**STAFF RECOMMENDATION**  
**208-210 Broadway**  
**November 16, 2016**

**Application:** New construction-addition, Alterations  
**District:** Broadway Historic Preservation Zoning Overlay  
**Council District:** 19  
**Map and Parcel Number:** 09306211100  
**Applicant:** Kristy Angyal/ Kip A. Moore & Associates  
**Project Lead:** Robin Zeigler, robin.zeigler@nashville.gov

<p><b>Description of Project:</b> The project is for rehabilitation of two contributing buildings and a rooftop addition on one of the buildings.</p> <p><b>Recommendation Summary:</b> Staff recommends approval with the conditions that:</p> <ol style="list-style-type: none"><li>1. Staff approve all materials, such as masonry, windows and doors, and the rooftop addition;</li><li>2. The setback area of the rooftop on 208 Broadway not have railings, lighting, poles, posts, signage, covering or any other alterations and the addition not be enclosed without approval of the MHZC; and,</li><li>3. The upper level windows of 208 Broadway be 4/4, 2/2 or 1/1 rather than a mix of divisions.</li></ol> <p>With these conditions, the project meets the design guidelines for alterations and rooftop additions.</p>	<p><b>Attachm

PROPOSED  
**EAST (ALLEY) ELEVATION**      1/8" = 1' - 0"

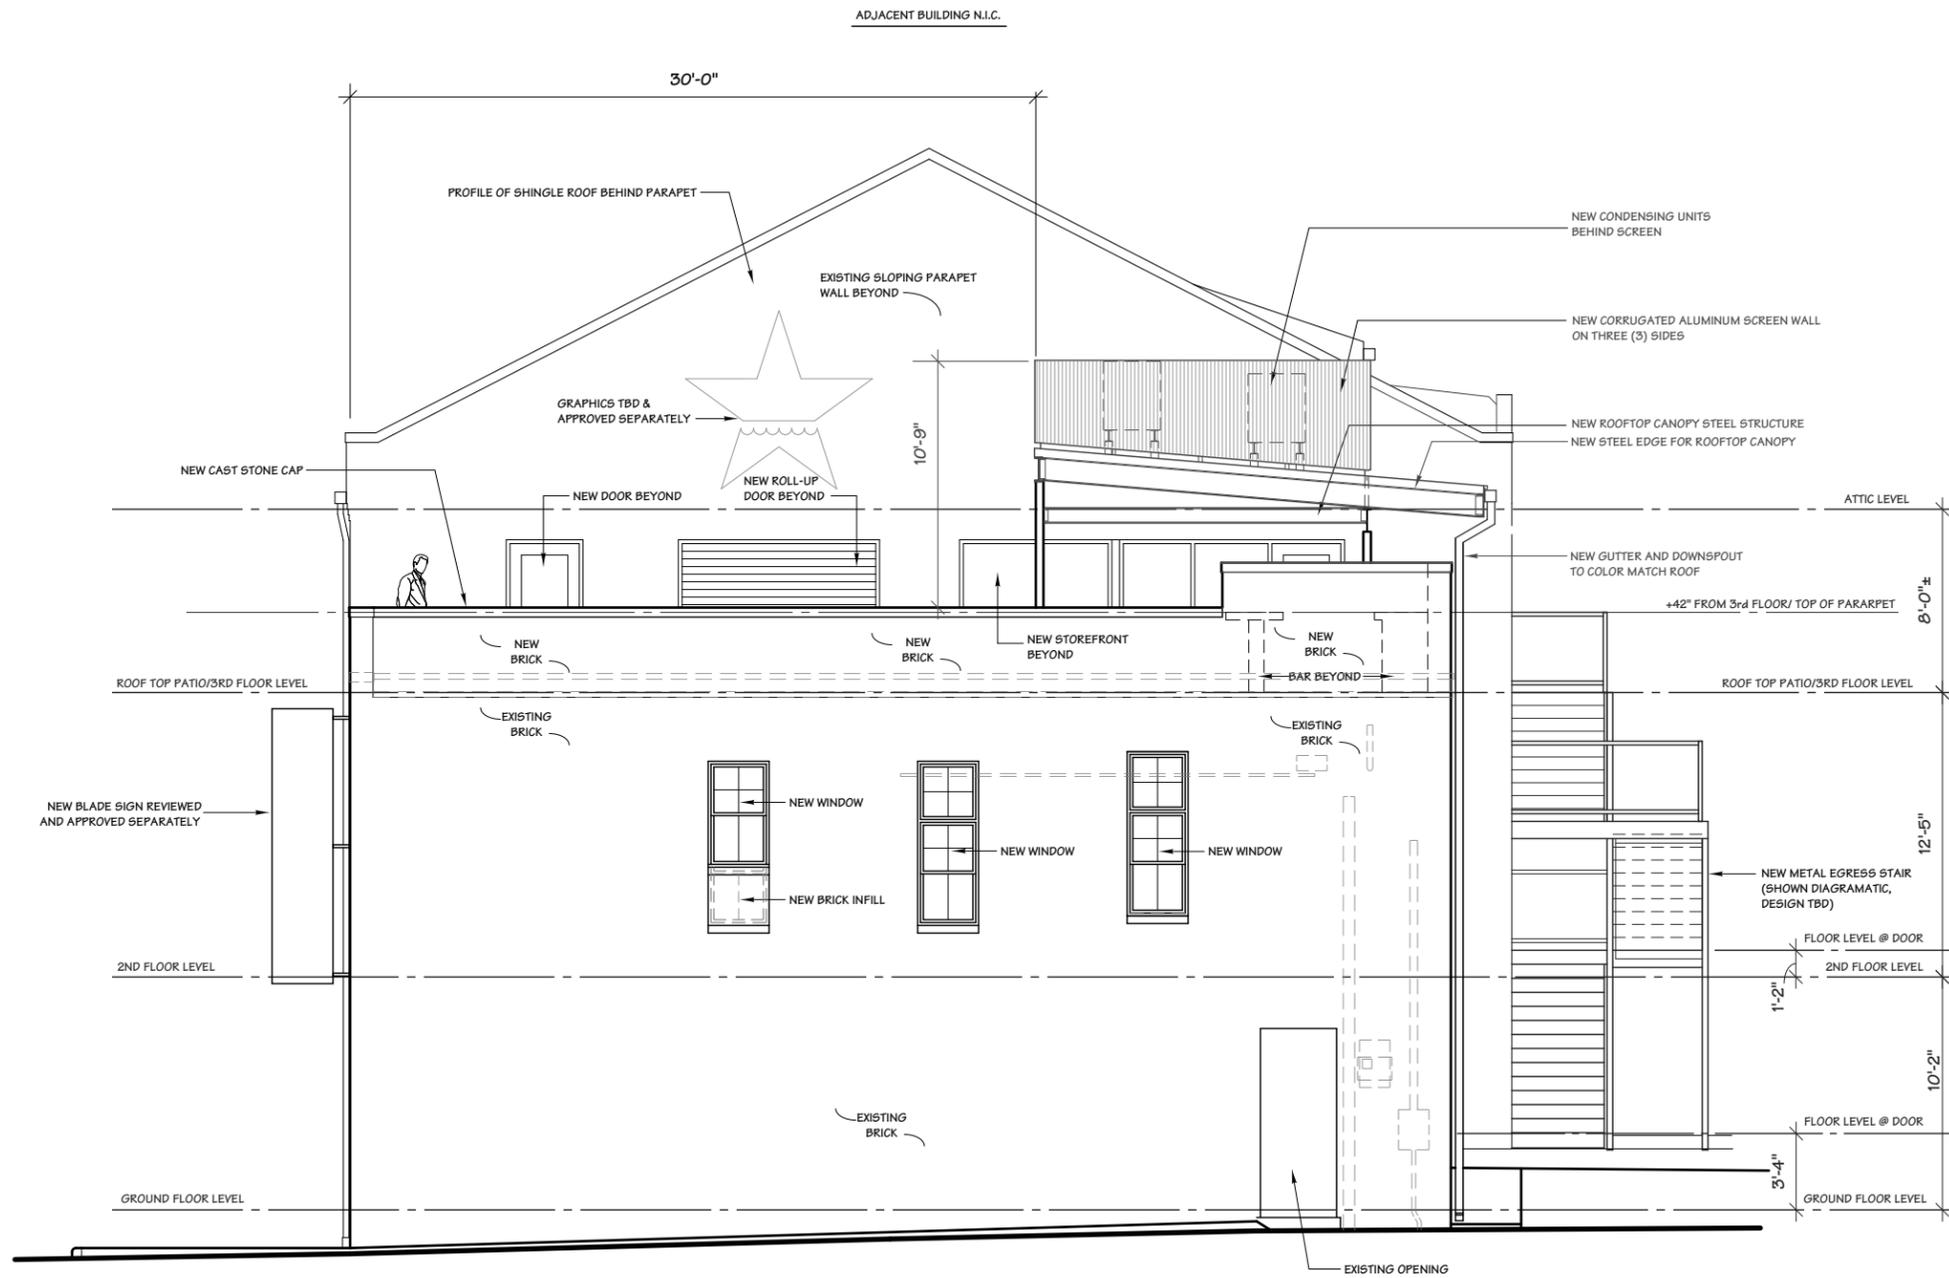
The right side, upper level of 208 Broadway faces an alley. Two existing windows will be altered in dimension and one will be enclosed. Staff finds this to be appropriate since this elevation is not a public façade and the windows are not character defining features. The front, right side, and rear walls of 208 Broadway will increase by approximately three-feet (3') to create a parapet wall and include one-inch (1") recessed panels with sills matching the windows below on the front. Since this building used to be three-stories and parapet walls are a common roof form in the district, staff finds the alteration to meet the design guidelines. It is not known if an exact match to the existing brick is possible; however, a variation in brick will show how the building has changed over time and distinguish new from old. With staff's approval of brick and stone, the project meets design guideline II.I and II.L.5.

PROPOSED  
ROOF-TOP PATIO PLAN

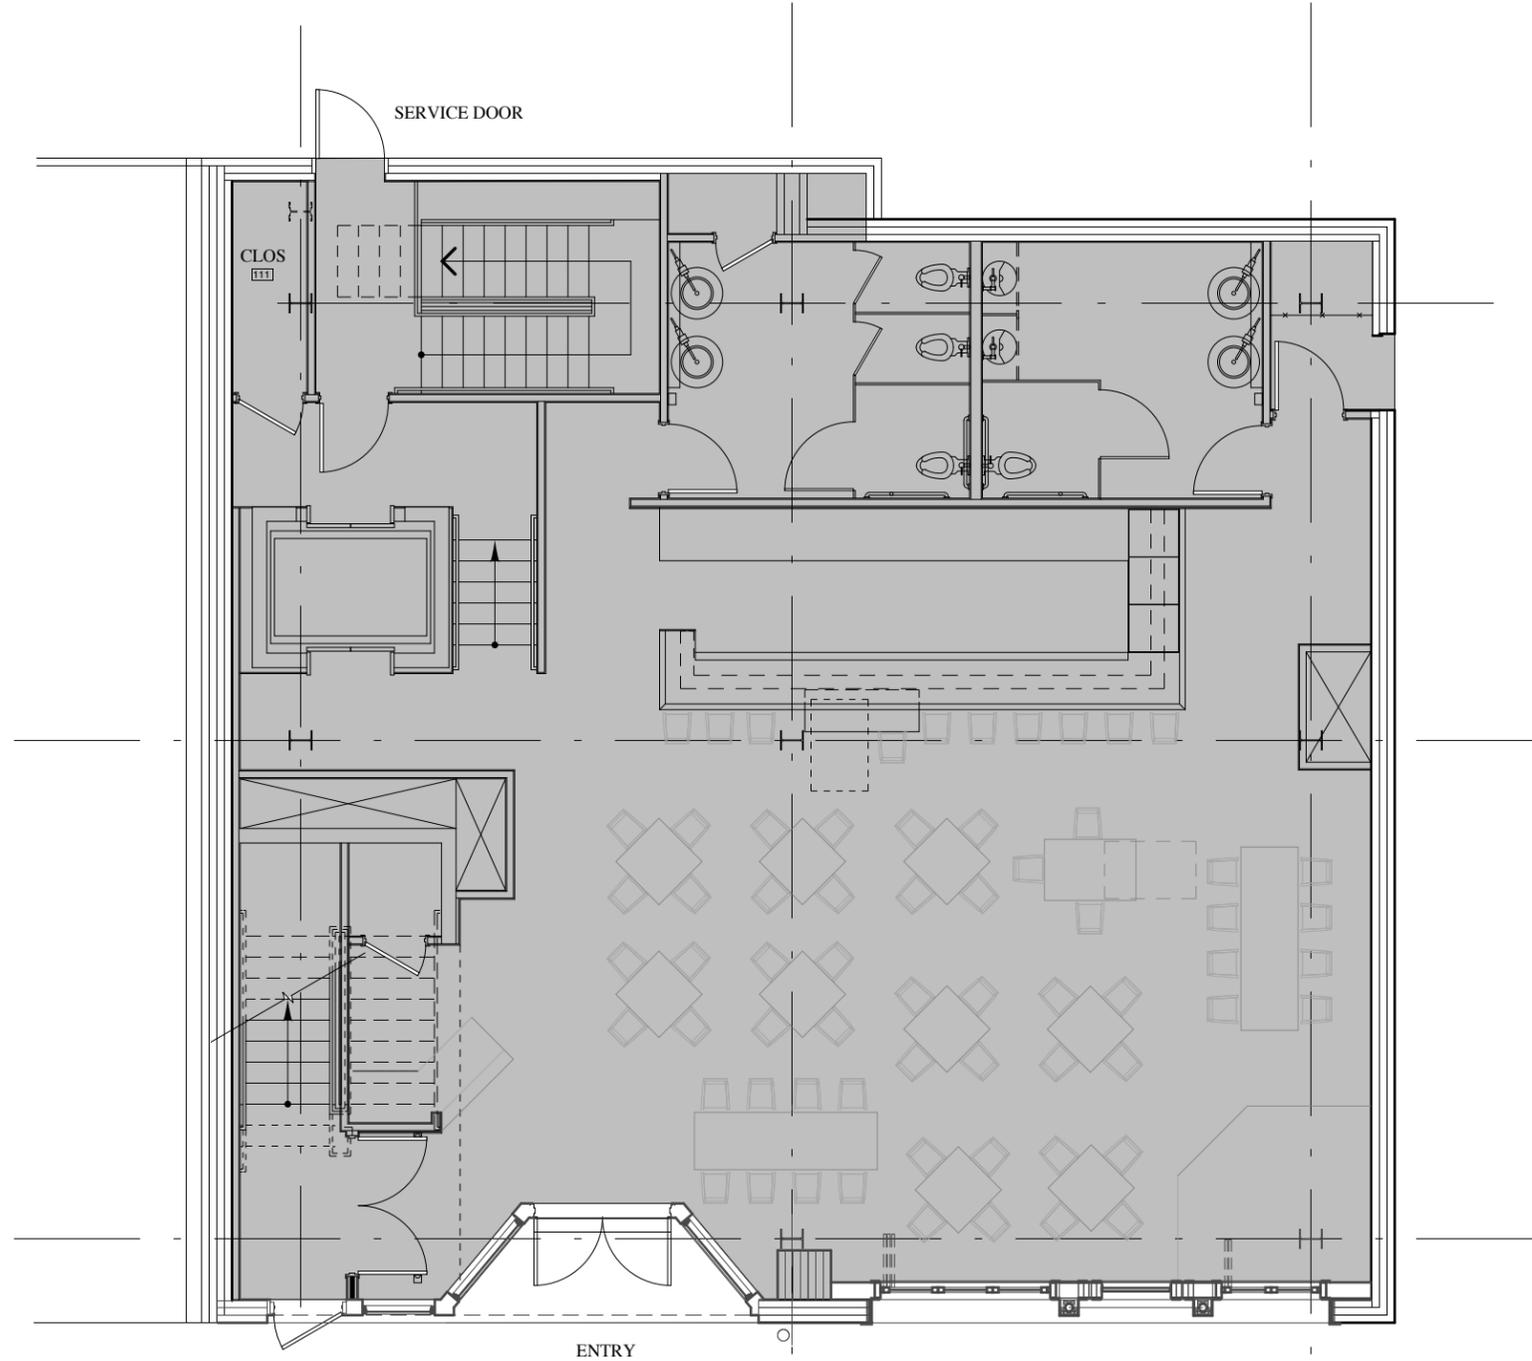
**Rooftop Addition:** The covered portion of the rooftop addition will be approximately thirteen feet (10') taller than the new front parapet wall and stepback the required thirty feet (30'). A side stepback is not required since this is not a corner lot. A railing is not required since the parapet wall will serve the same function. The only items to be located in the stepback area are non-permanent tables and chairs. Staff recommends a condition that the stepback area not have railings, lighting, poles, posts, signage, covering or any other alterations without approval of the MHZC. The addition itself is a shed roof structure without sides and metal screen on top for mechanicals. Staff recommends that the addition not be enclosed without approval of the MHZC. The project meets section III.H.

4. Staff approve all materials, such as masonry, windows and doors, and the rooftop addition;
5. The stepback area of the rooftop on 208 Broadway not have railings, lighting, poles, posts, signage, covering or any other alterations and the addition not be enclosed without approval of the MHZC; and,
6. The upper level windows of 208 Broadway be 4/4, 2/2 or 1/1 rather than a mix of divisions.
